**State of Alaska
Department of Fish and Game
Sportfish Division**

**Nomination Form
Anadromous Waters Catalog**

Anadromous Waters Catalog Number of Water Body 247-41-10200-2081-3035 (-0030); 247-41-10200-2081-3057-4011 (-0020)

Nomination # <u>25-547</u>	 Fisheries Scientist	<u>5/19/2025</u> Date
Revision Year: <u>2026</u>	 Habitat Operations Manager	<u>05/19/2025</u> Date
Revision to: <input checked="" type="checkbox"/> Atlas <input checked="" type="checkbox"/> Catalog	 AWC Project Biologist	<u>22 April 2025</u> Date
Revision Code: <u>C-9, C-1a, C-8, C-1, D-1</u>	 GIS Analyst	<u>7/11/2025</u> Date

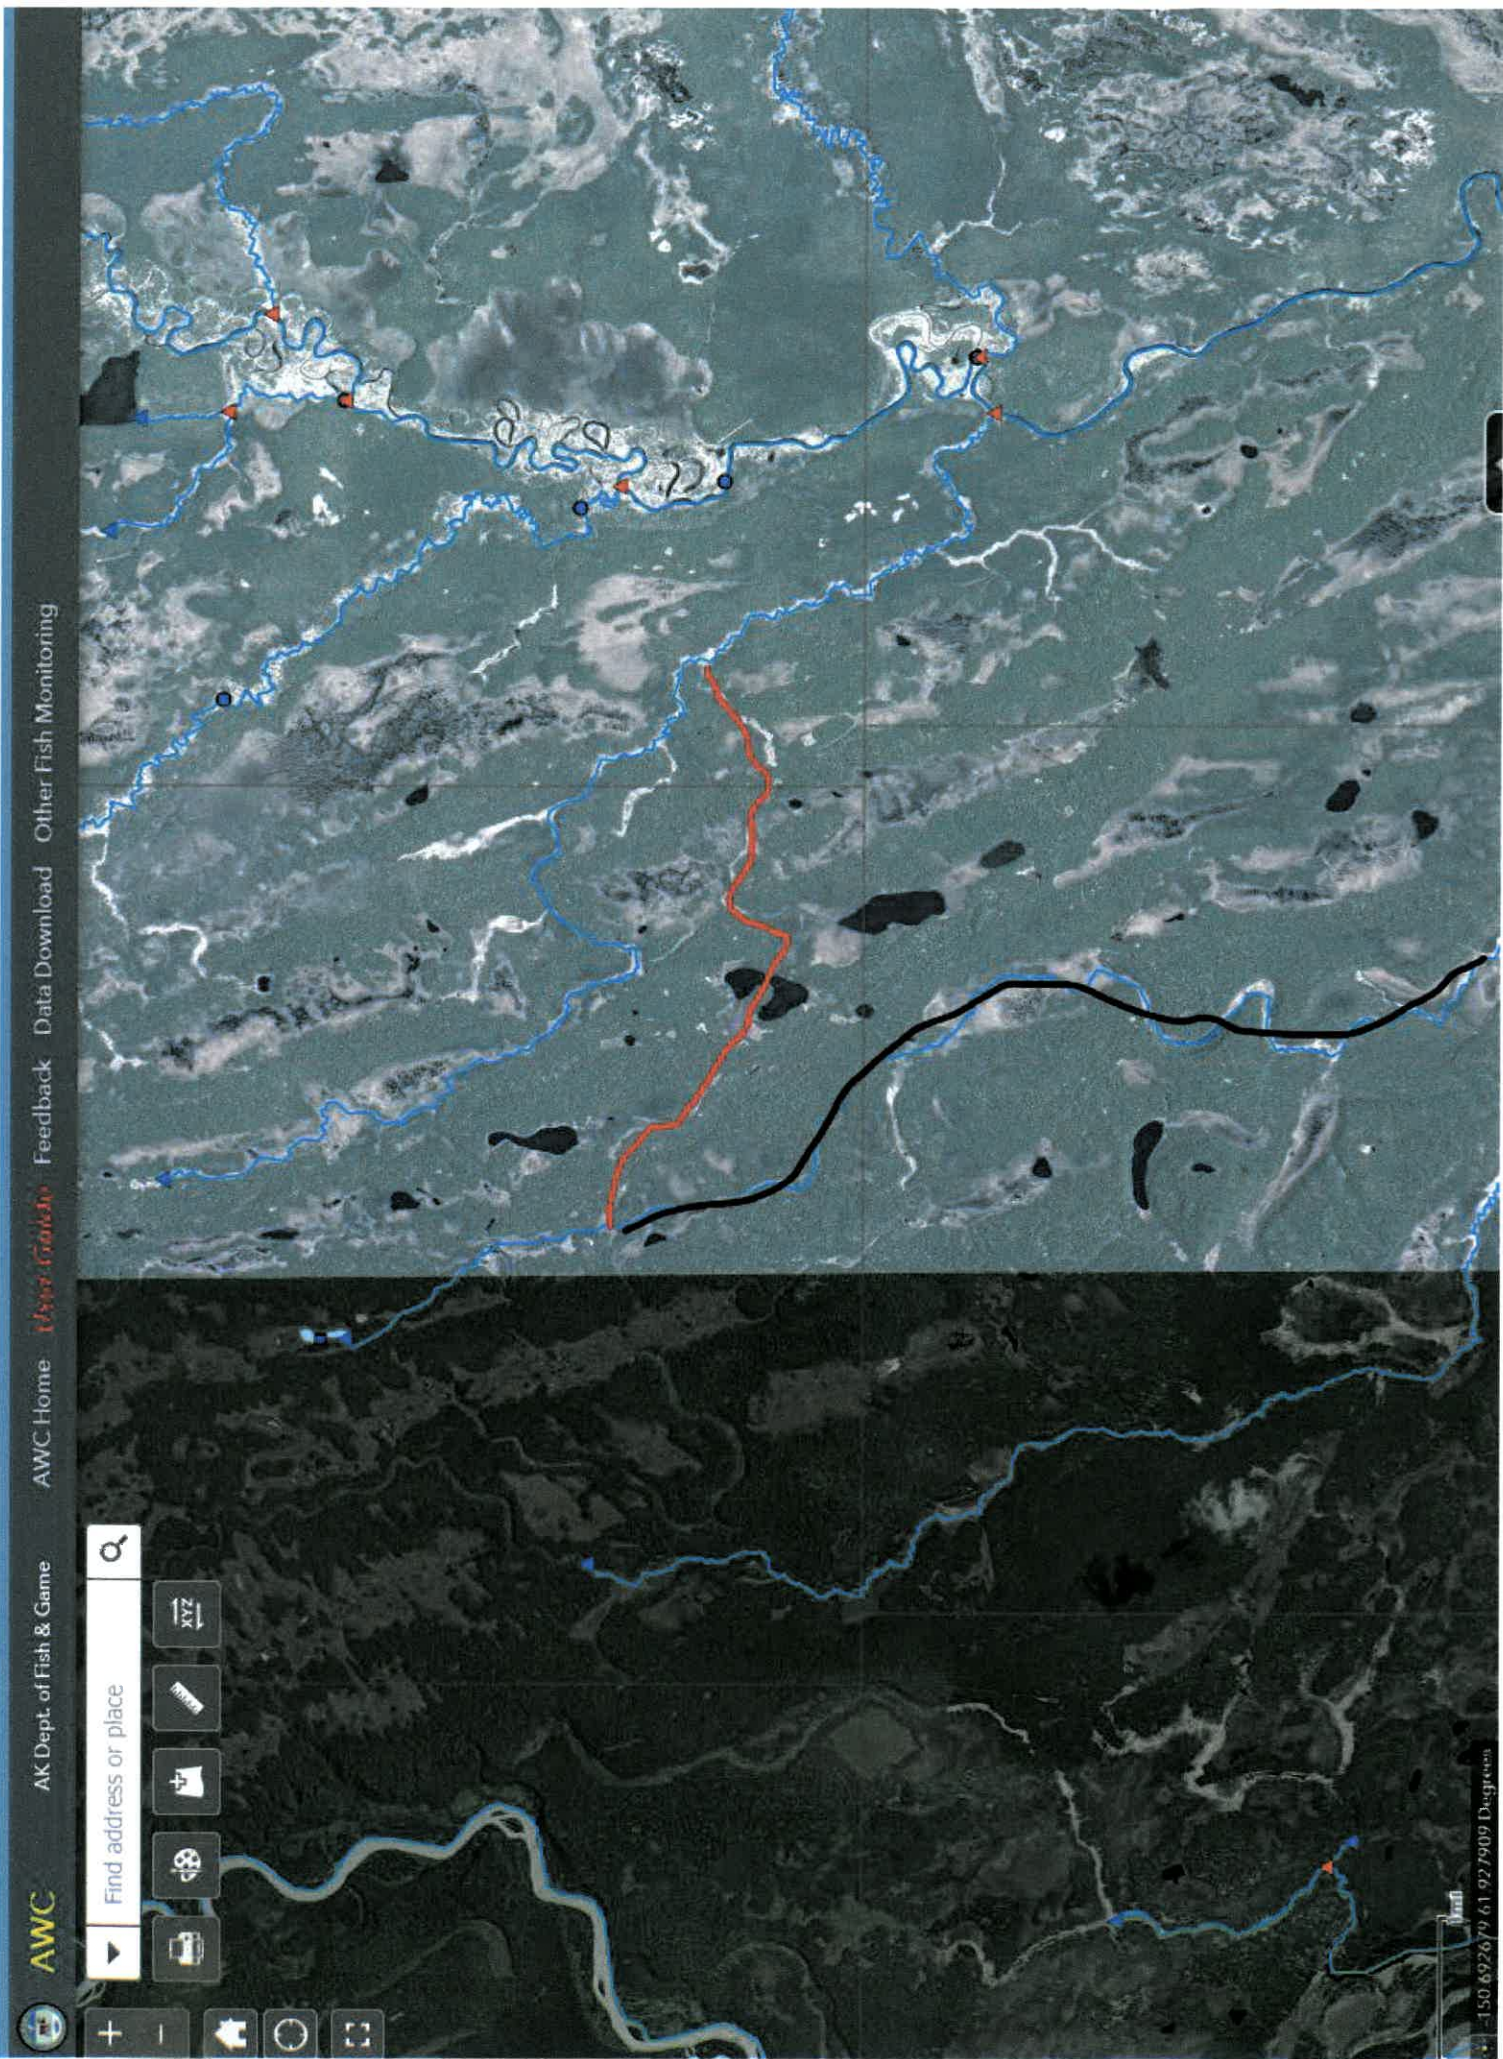
Was huntin around in the AWC and think I might have come across an error with nomination 89-174 (attached) on 247-41-10200-2081-3035. The blue line in the AWC matches what's in the nomination, but at 61.883922, -150.549614 (which looks to be the location of their 4-B-1 sample location, the blue line looks like it should have gone to the east based on aerial imagery, rather than continue south. The blue line south of this point looks to go over dry land. My guess is back then before aerial imagery, it was hard to tell where water flowed on maps like this?

I've attached a map of where the line should probably be in Red, and the line that shouldn't be there in Black. The "incorrect" line eventually finds its way back to a legitimate stream, but not sure if there's any other nominations supporting anadromy in that one?

Map #2

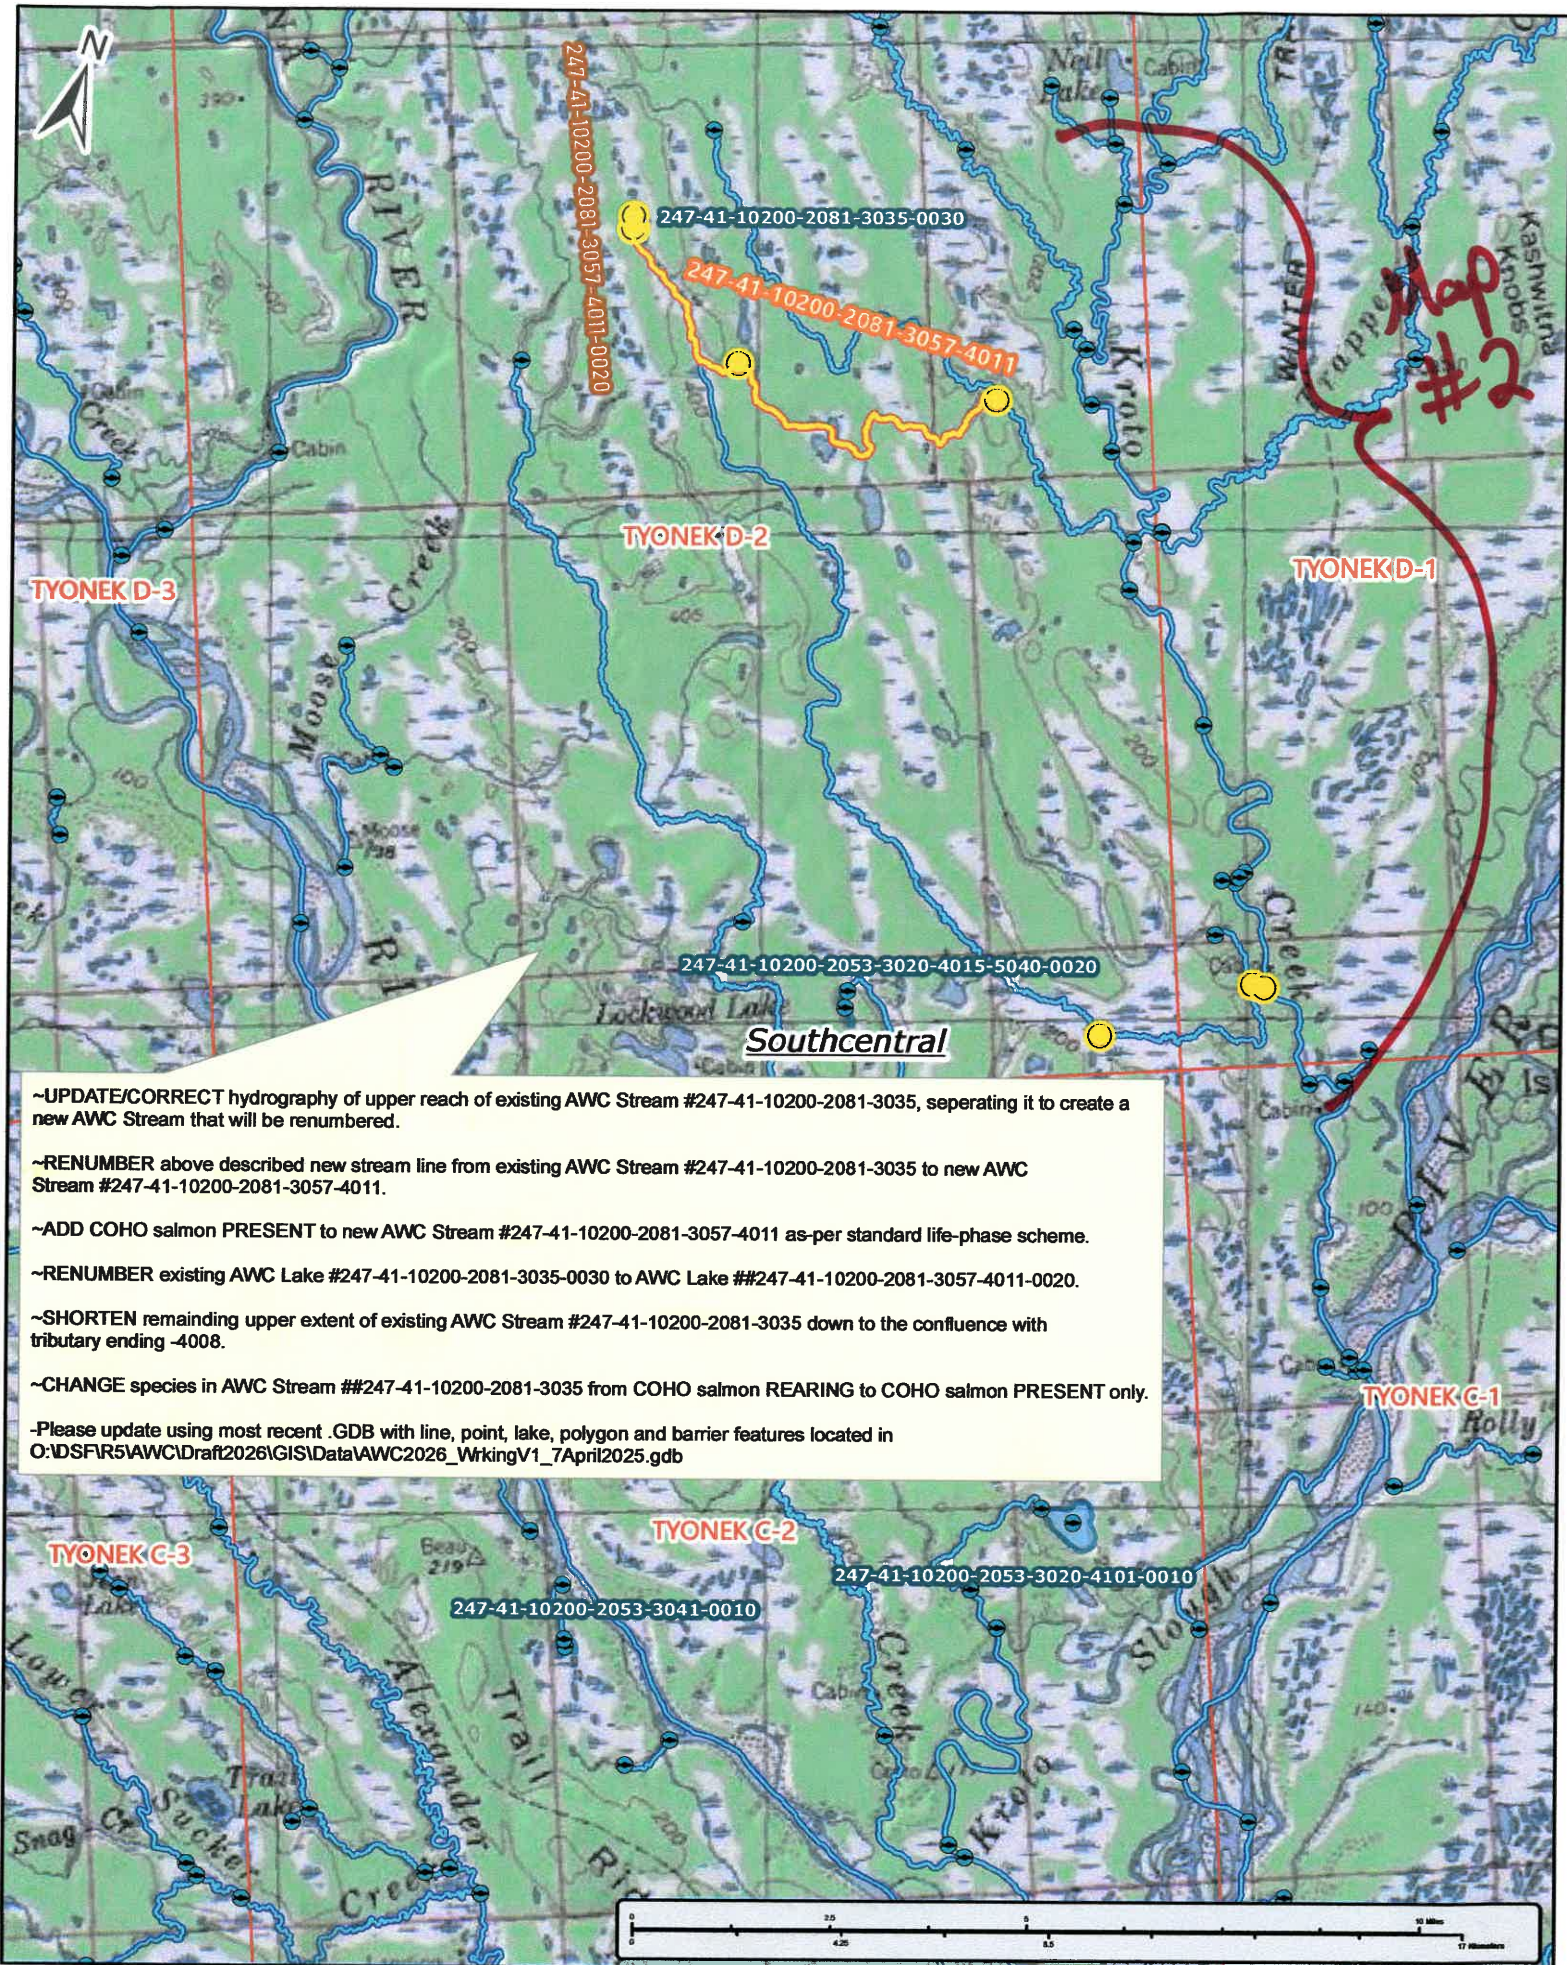
- UPDATE/CORRECT hydrography of upper reach of existing AWC Stream #247-41-10200-2081-3035, separating it to create a new AWC Stream that will be renumbered.

- RENUMBER above described new stream line from existing AWC Stream #247-41-10200-2081-3035 to new AWC Stream #247-41-10200-2081-3057-4011.
- ADD COHO salmon PRESENT to new AWC Stream #247-41-10200-2081-3057-4011 as per standard life-phase scheme.

- RENUMBER existing AWC Lake #247-41-10200-2081-3035-0030 to AWC Lake ##247-41-10200-2081-3057-4011-0020.
- SHORTEN remaining upper extent of existing AWC Stream #247-41-10200-2081-3035 down to the confluence with tributary ending -4008.

- CHANGE species in AWC Stream ##247-41-10200-2081-3035 from COHO salmon REARING to COHO salmon PRESENT only.
- Please update using most recent .GDB with line, point, lake, polygon and barrier features located in O:\DSFR5\AWC\Draft2026\GIS\Data\AWC2026_WrkingV1_7April2025.gdb

Map #1

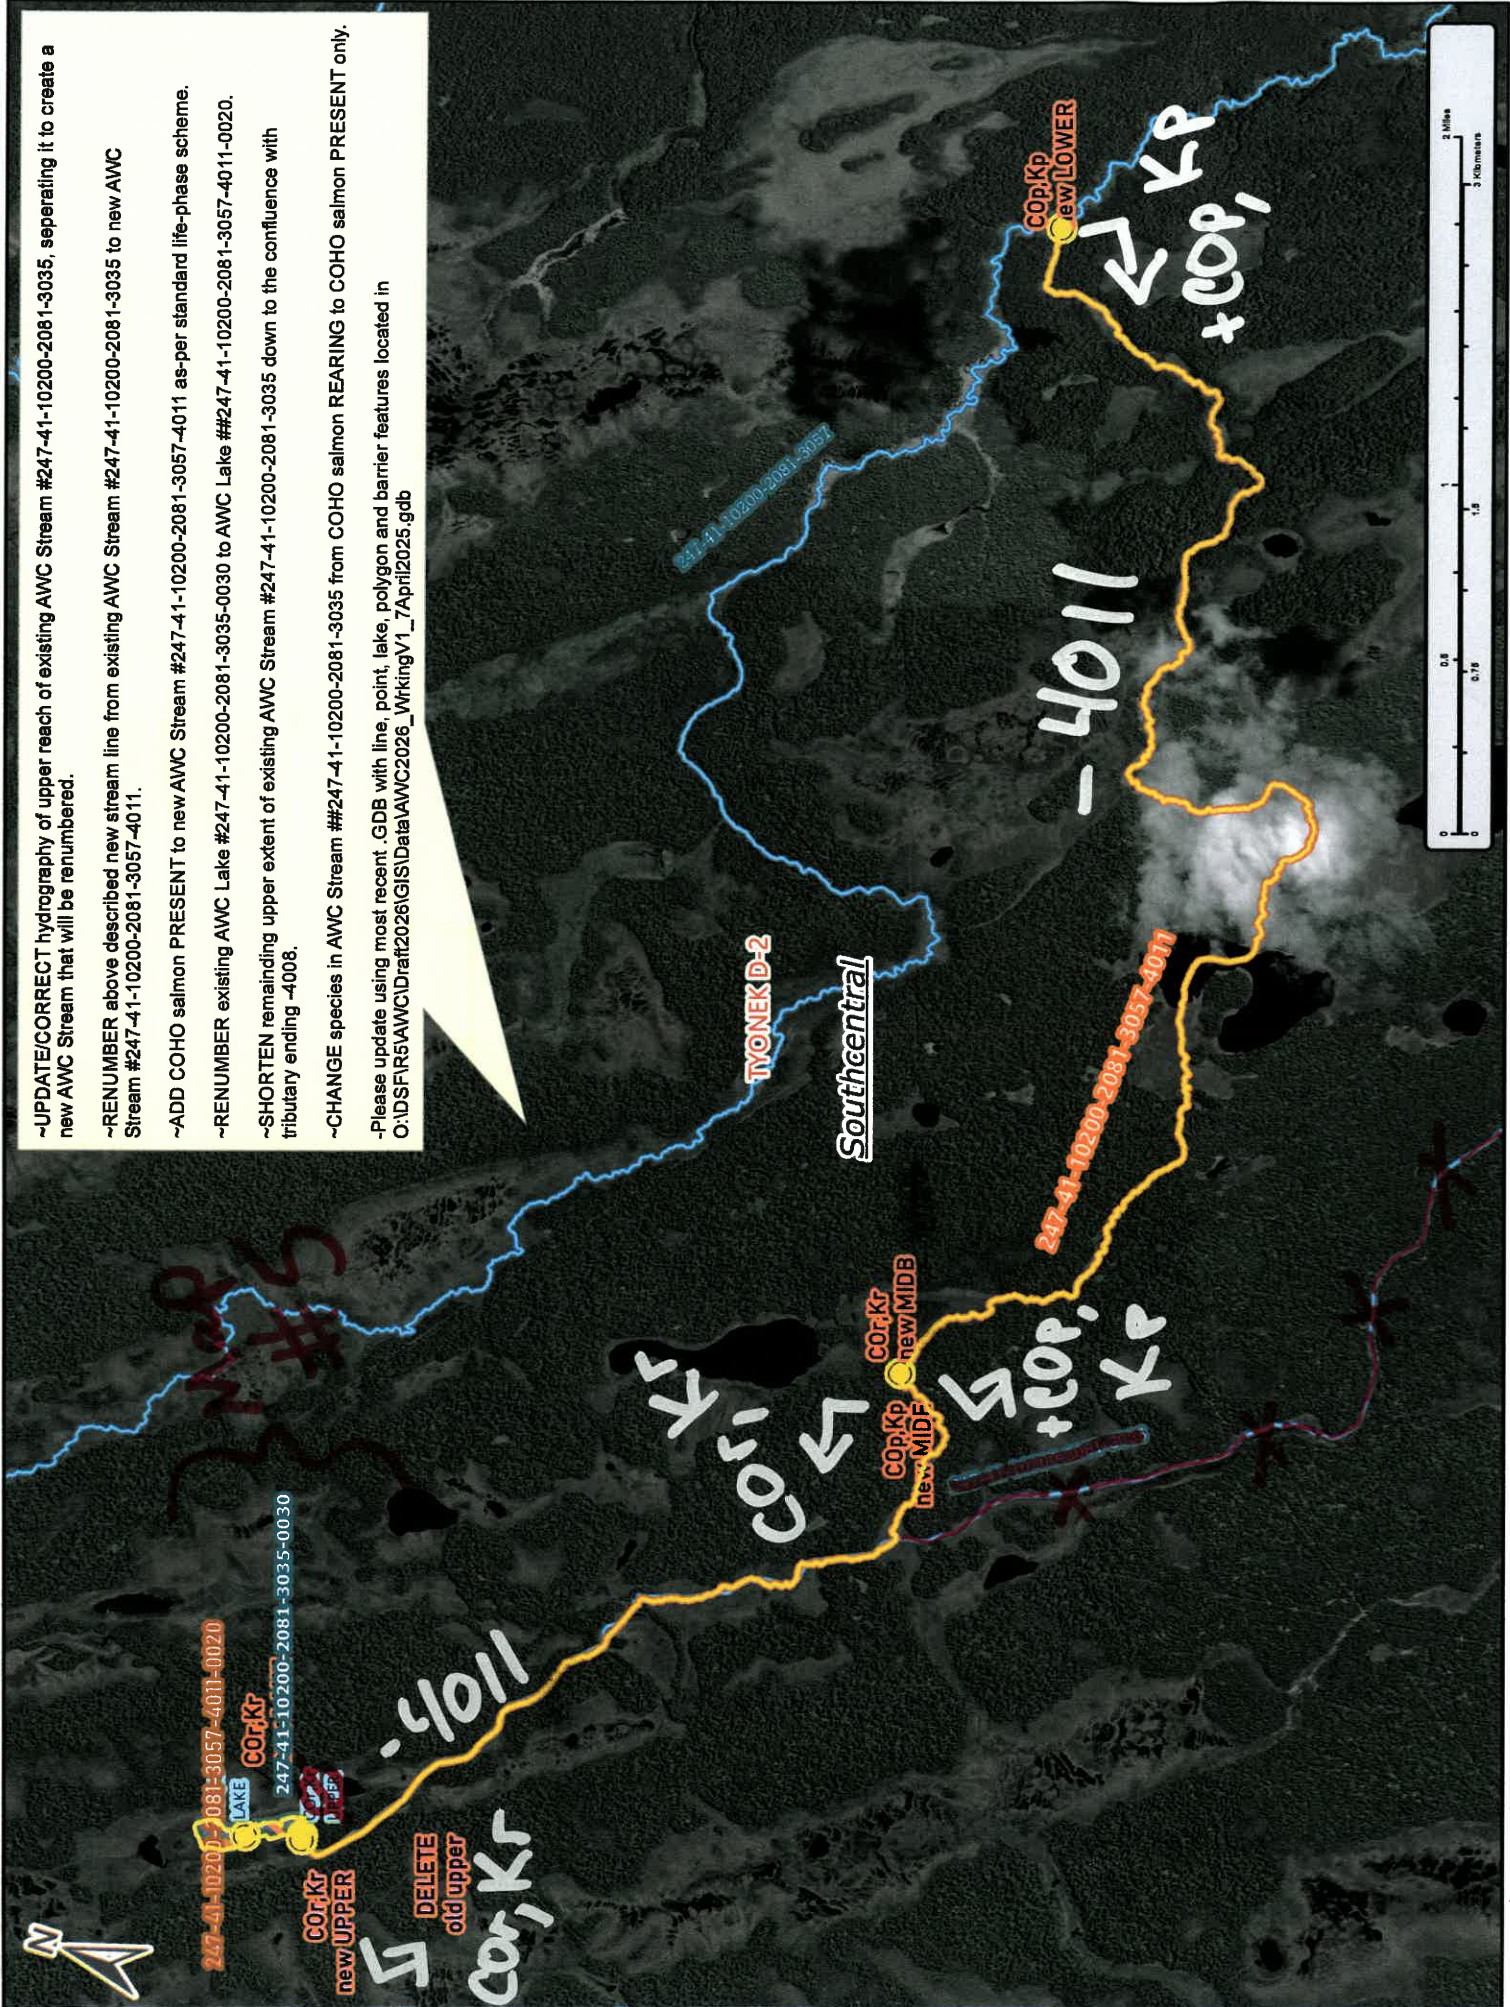
- UPDATE/CORRECT hydrography of upper reach of existing AWC Stream #247-41-10200-2081-3035, separating it to create a new AWC Stream that will be renumbered.

- RENUMBER above described new stream line from existing AWC Stream #247-41-10200-2081-3035 to new AWC Stream #247-41-10200-2081-3057-4011.
 - ADD COHO salmon PRESENT to new AWC Stream #247-41-10200-2081-3057-4011 as-per standard life-phase scheme.

- RENUMBER existing AWC Lake #247-41-10200-2081-3035-0030 to AWC Lake ##247-41-10200-2081-3057-4011-0020.
 - SHORTEN remaining upper extent of existing AWC Stream #247-41-10200-2081-3035 down to the confluence with tributary ending -4008.

- CHANGE species in AWC Stream ##247-41-10200-2081-3035 from COHO salmon REARING to COHO salmon PRESENT only.
- Please update using most recent .GDB with line, point, lake, polygon and barrier features located in O:\DS\FIR5\AWC\Draft2026\GIS\Data\AWC2026_WrkingV1_7April2025.gdb
